RIDGWAY PLANNING COMMISSION

AGENDA

Tuesday, September 25th, 2018
Regular Meeting; 5:30 pm
Ridgway Community Center
201 North Railroad Street, Ridgway, Colorado

Subject: Preliminary Plat Submittal
Legal: Ridgway Land Company Subdivision Lots 30-34
Address: TBD Redcliff Drive
Parcel #s: 430516402012, 430516402011, 430516402010, 430516402009, 430516402008
Zone: General Commercial
Applicant: Joseph Nelson
Owners: Ridgway Land Co. / Rob Hunter
Initiated By: Shay Coburn, Planner
Date: September 25, 2018

SEWER VP LINE 2, 3, & 4 PLAN & PROFILE

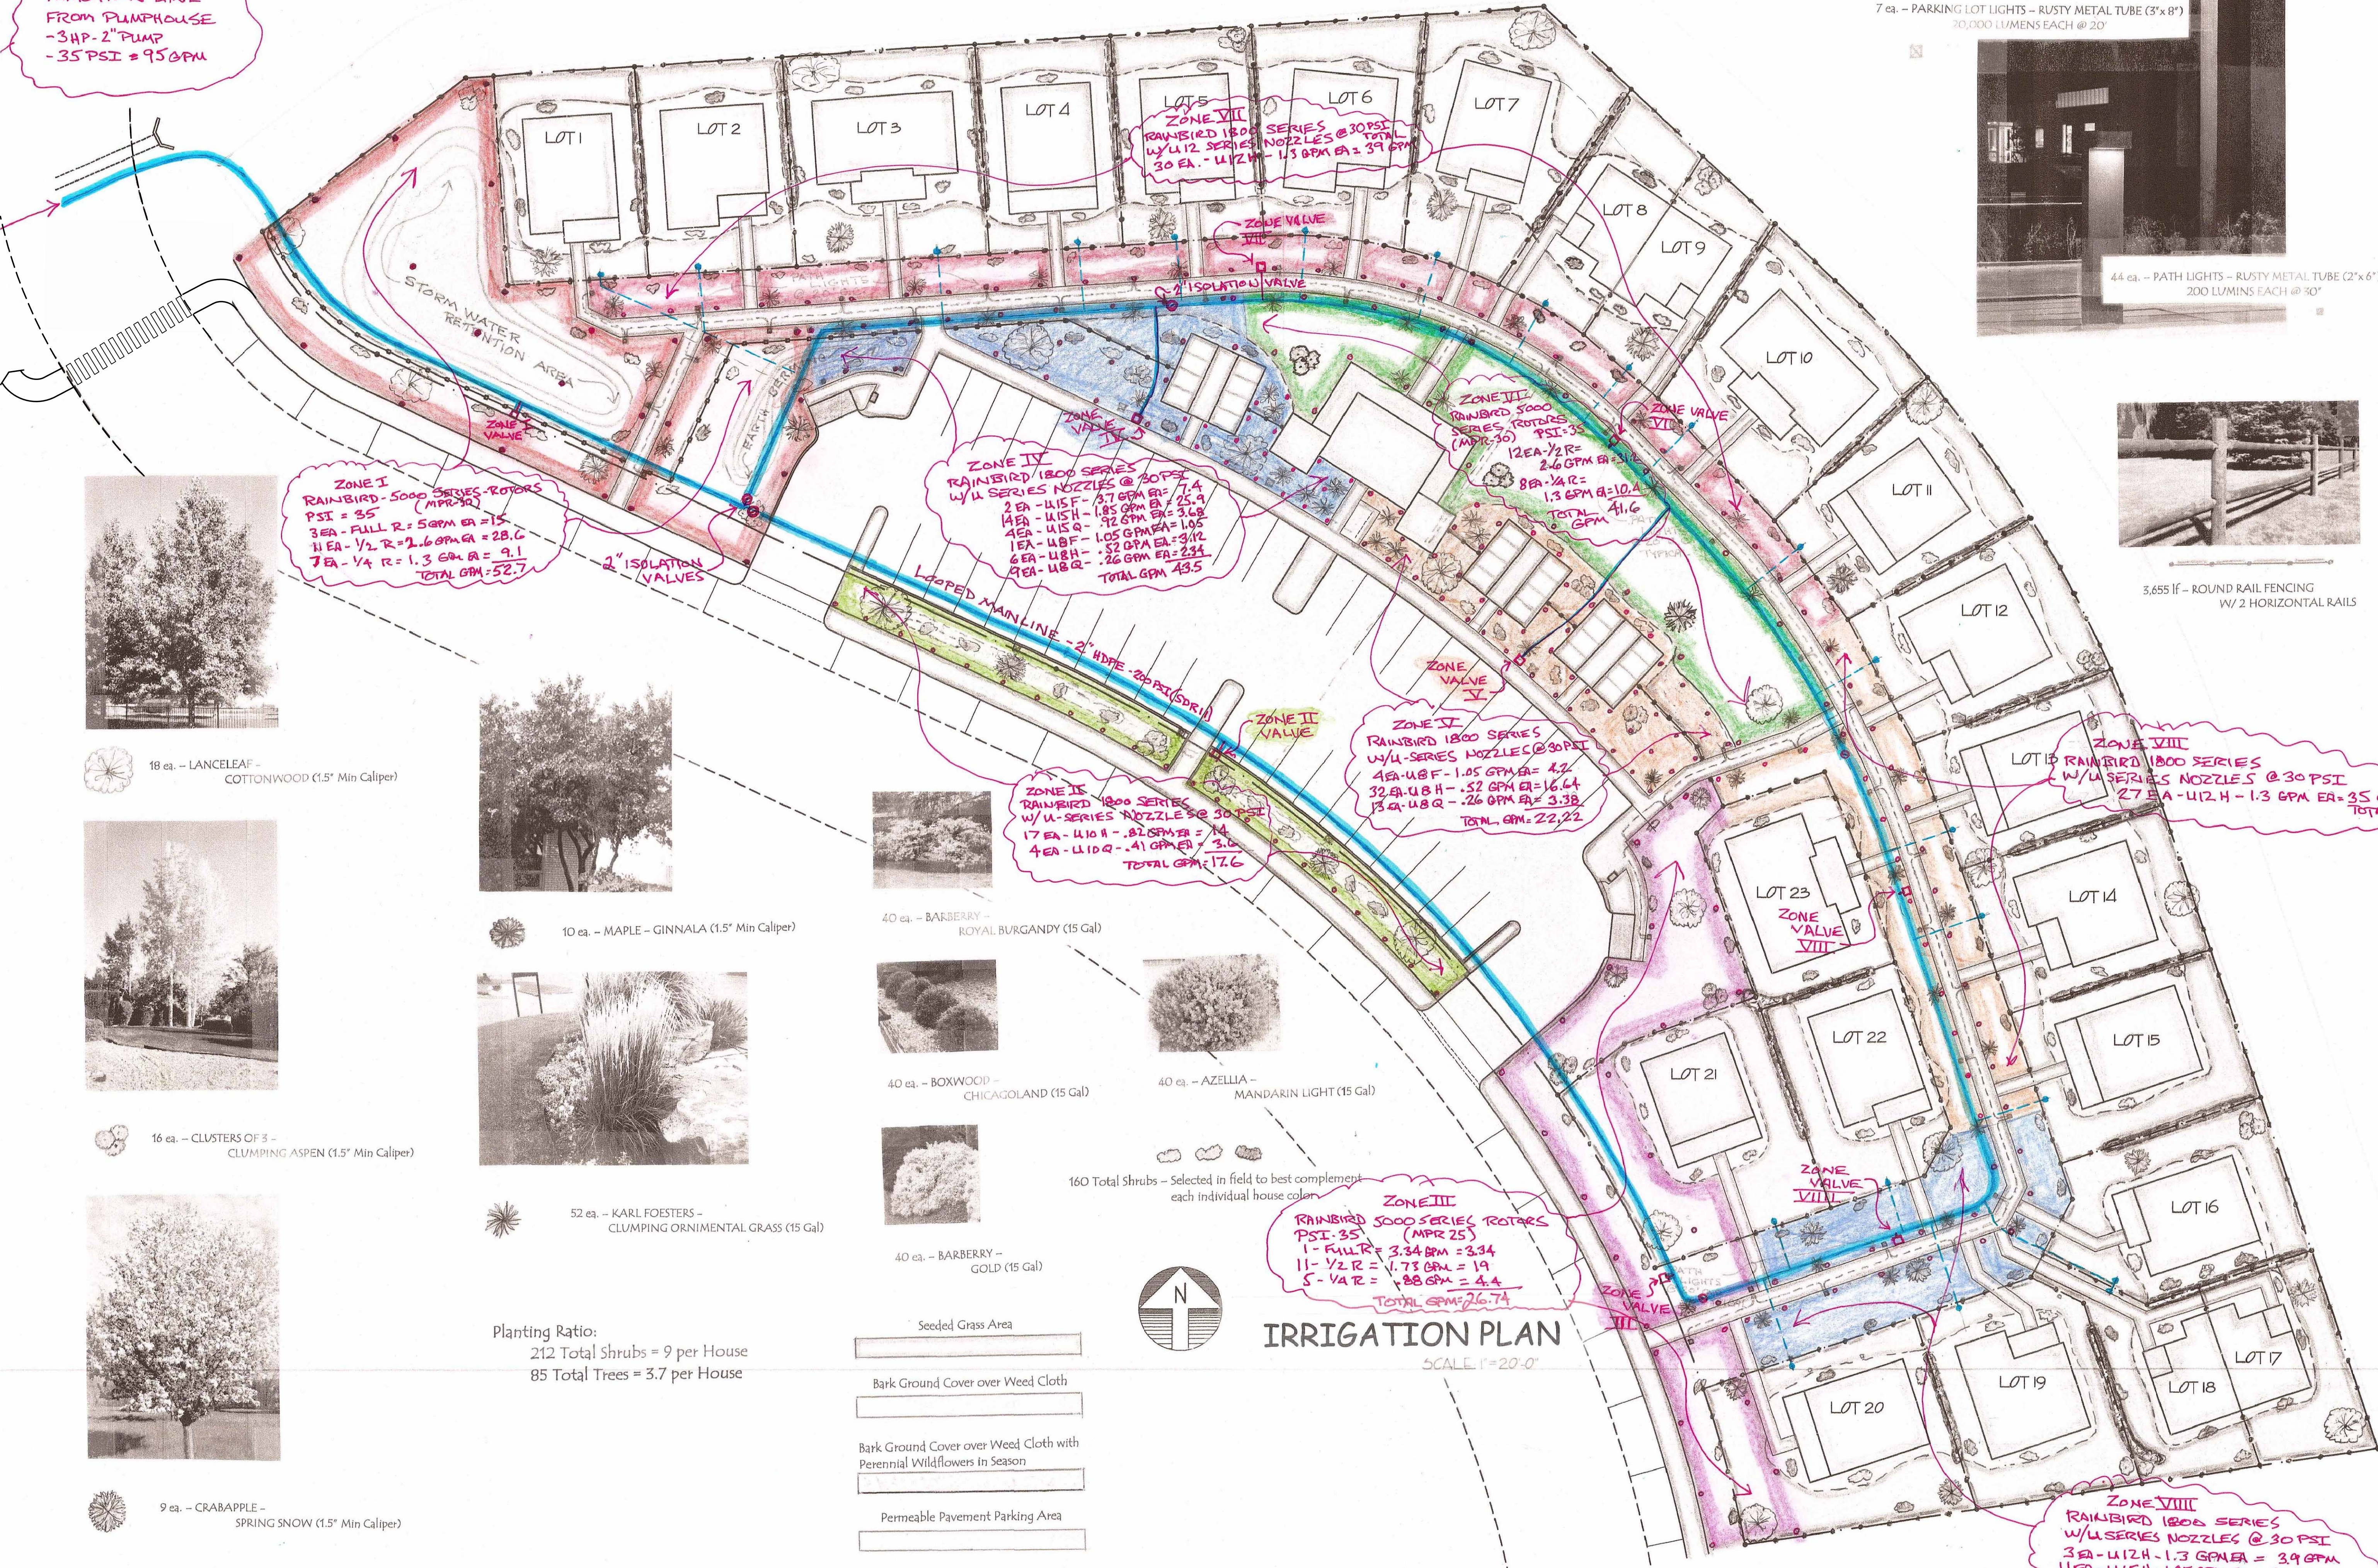
- Need encasements on the sewer at water line crossings in the profile drawings. *Done.*
- The manholes are very close to rear property lines which will make them difficult to maintain and replace if/when needed. These need to be move a few more feet away from the rear property line. Applicant has noted that this will be difficult to do. *Staff can make do with what is proposed.*

IRRIGATION PLAN

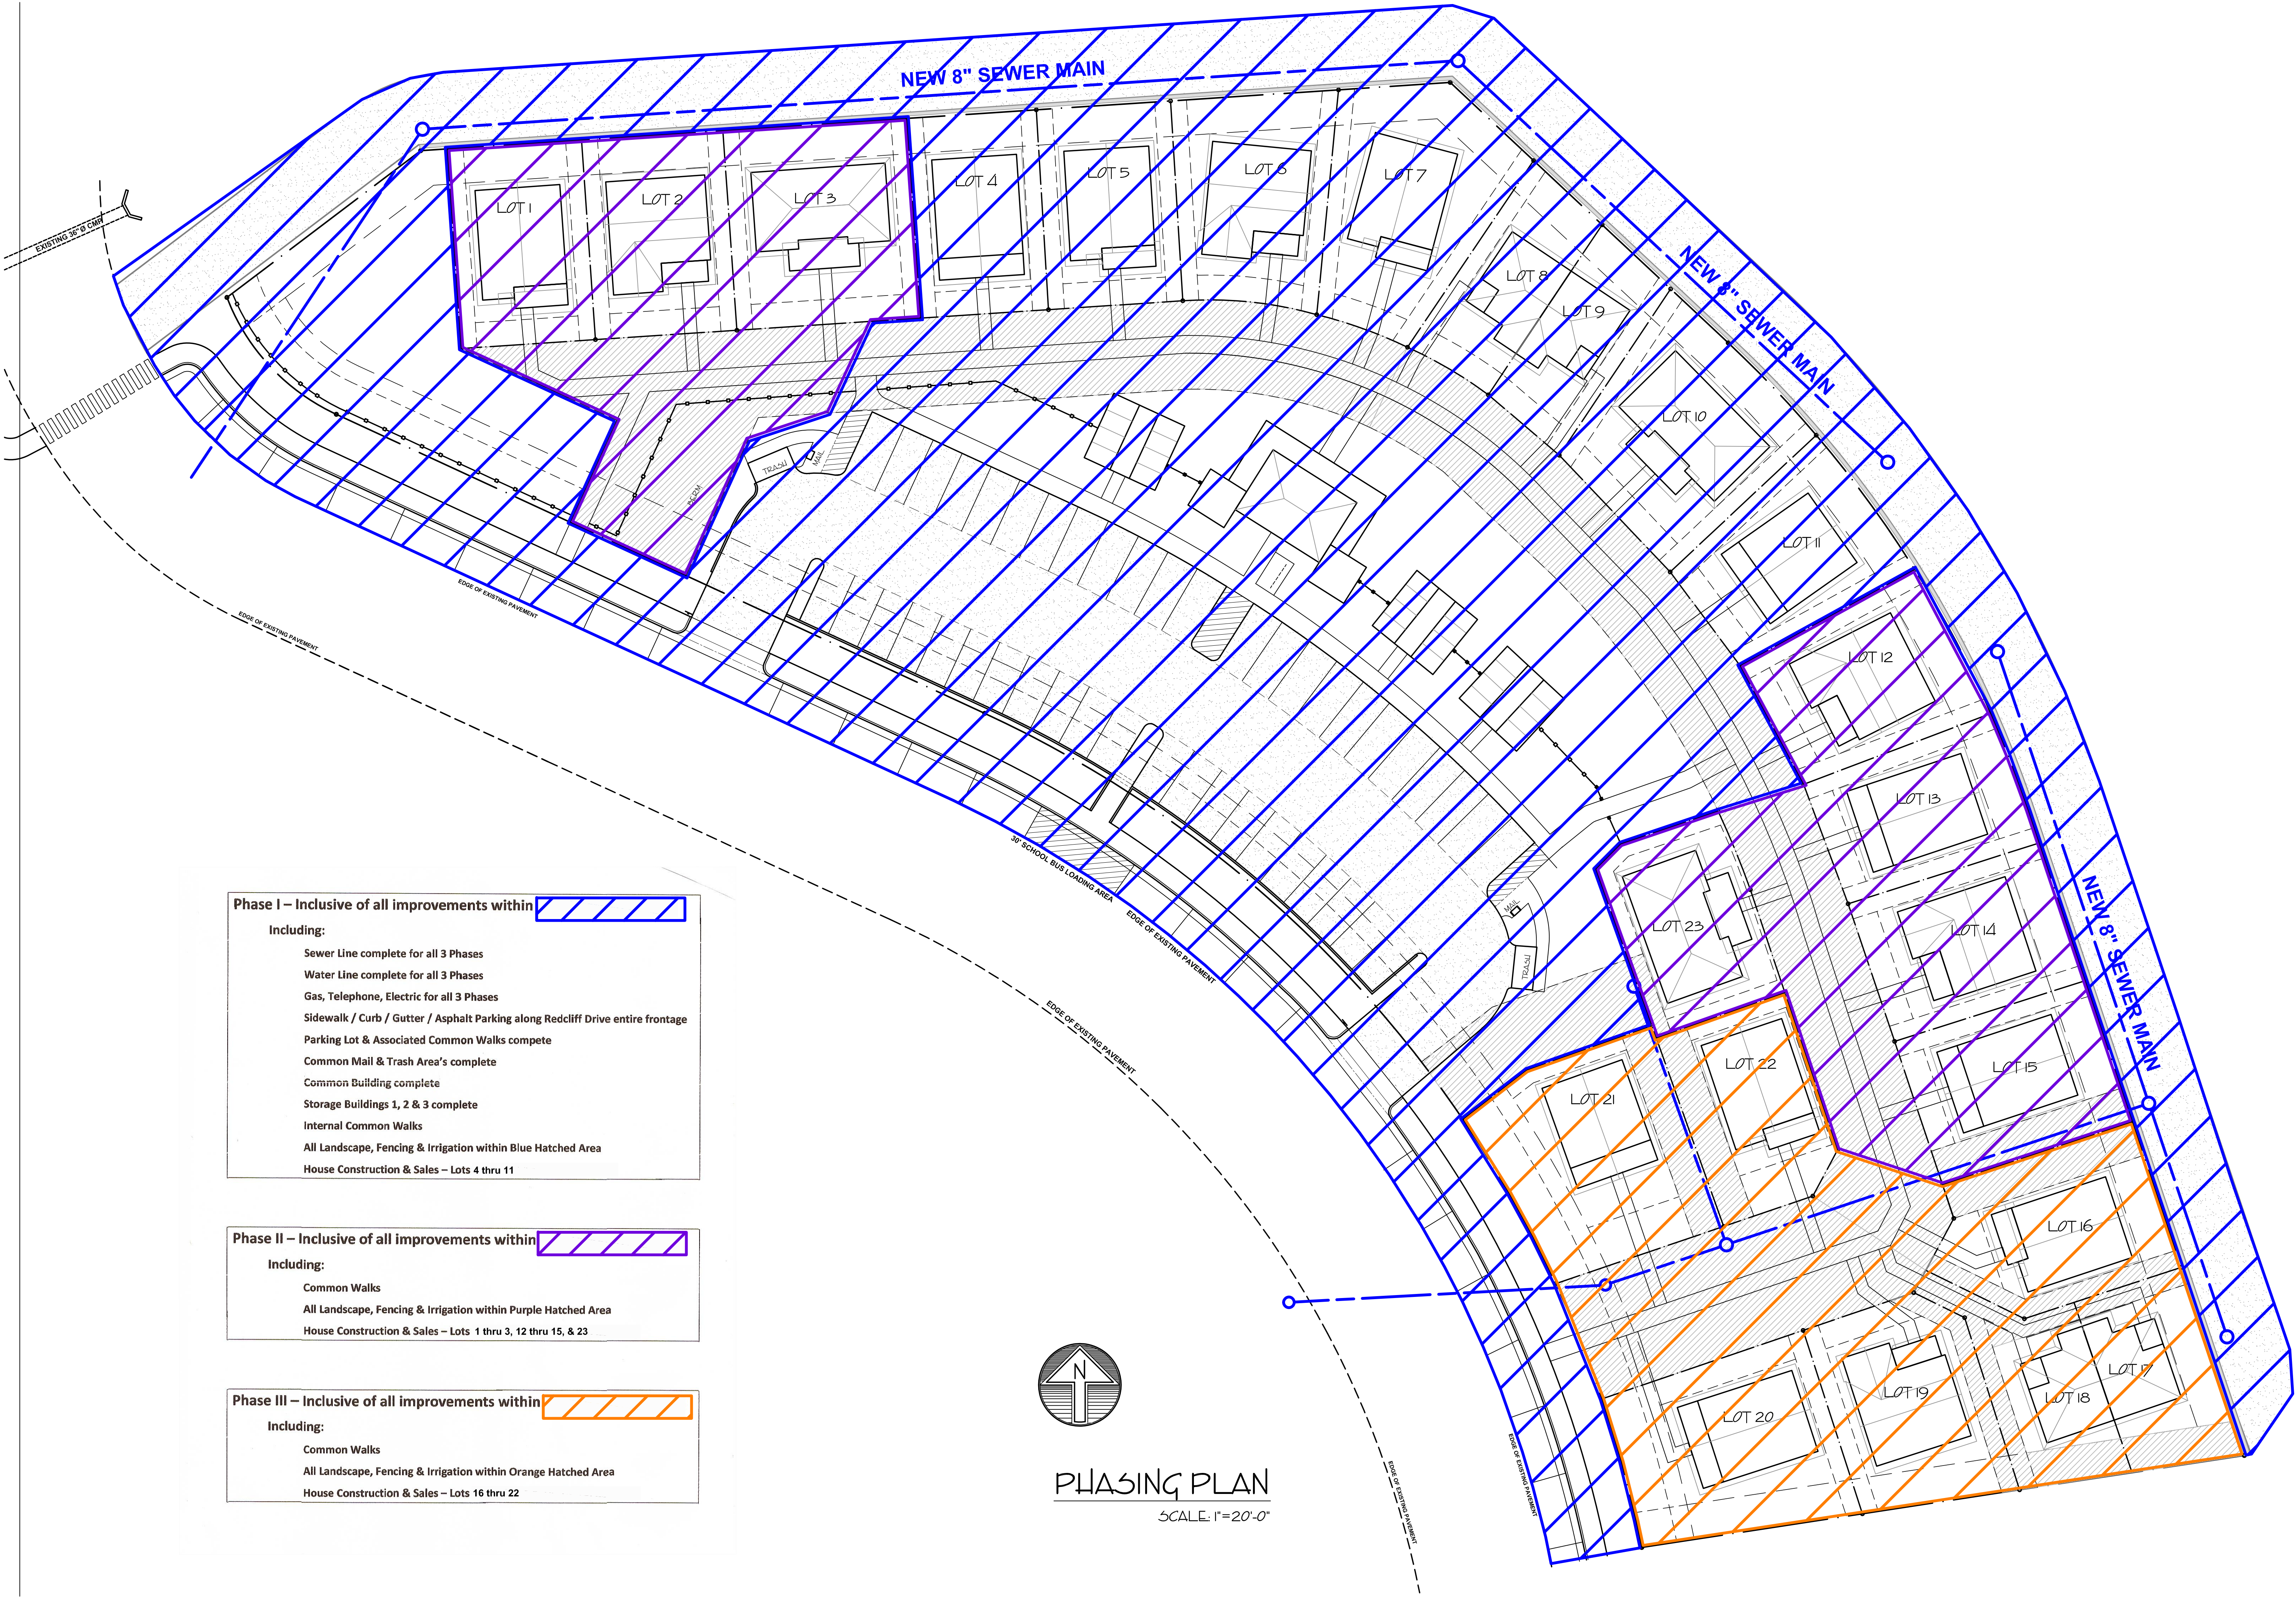
- Irrigations plans have not yet been submitted. These plans should be submitted before going to Town Council. An irrigation plan was submitted. It shows irrigation to all common areas. All proposed landscaping on private lots will not be irrigated. How will each property owner irrigate their own property? From their potable water tap? Will future owners reasonably be able to keep the trees, shrubs and grass area per the landscape plans alive? Will owners be allowed to tap into the irrigation water of the HOA? Will there be a distribution line with a spigot for each lot? RUSA was intended to all be watered with this irrigation water.

PHASING PLAN

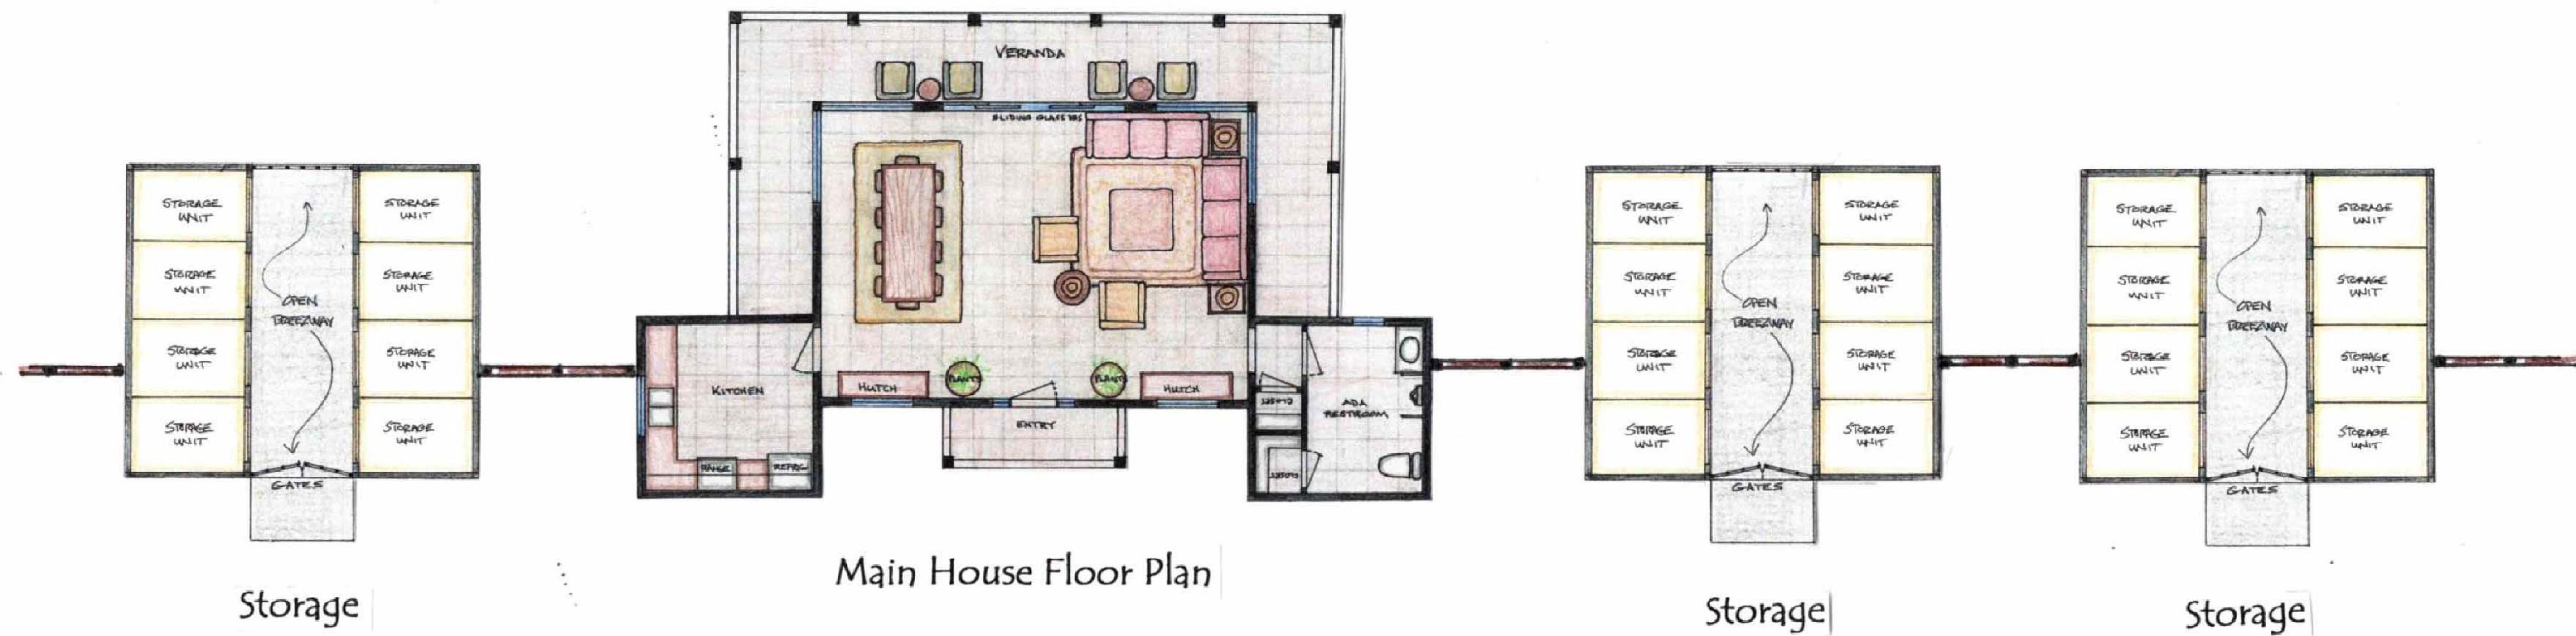
1. Is there a plan to final plat in phases or just build in phases? Staff has received contradicting information from the Applicant. [Will final plat in phases. See updated phasing plan.](#)
2. On sheet PH-1 the hatching and text do not agree. Which is correct? [Fixed.](#)
3. Assuming grading, drainage and ditch relocation will be part of phase 1. Needs to be on plans. [Not addressed. Needs included.](#)
4. Assuming construction of storage building 4 will be part of phase II. Add to plans. [Removed storage building 4.](#)
